AMENDMENTS TO THE DRAWINGS

Application No.: 10/734572

Docket No.: 53807-00066USPT

ANNOTATED SHEET SHOWING CHANGES TO FIGURE 7

FIG. 7
(PRIOR ART)

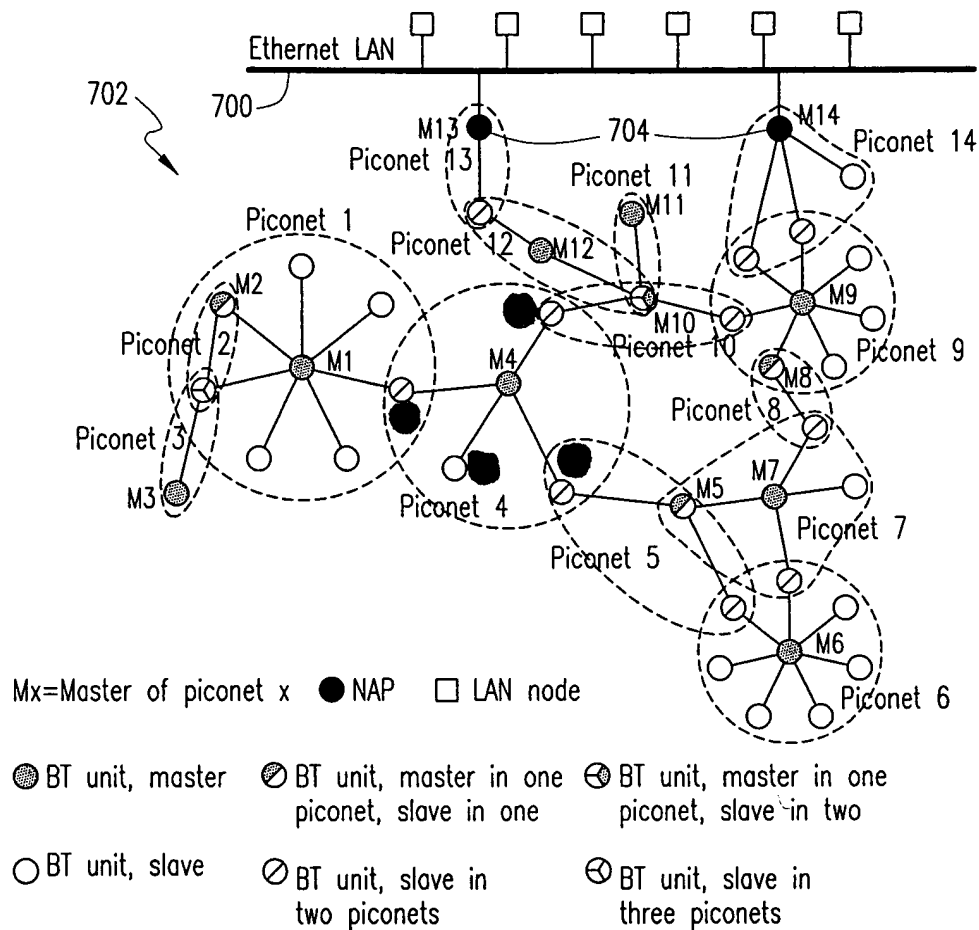
Figure 7 of the drawings is hereby amended to add the reference labels "S1," "S2," "S3," and "S4" to the four nodes directly connected to node "M4." Support for the amendment may be found in the specification in the paragraph bridging pages 31 and 32.
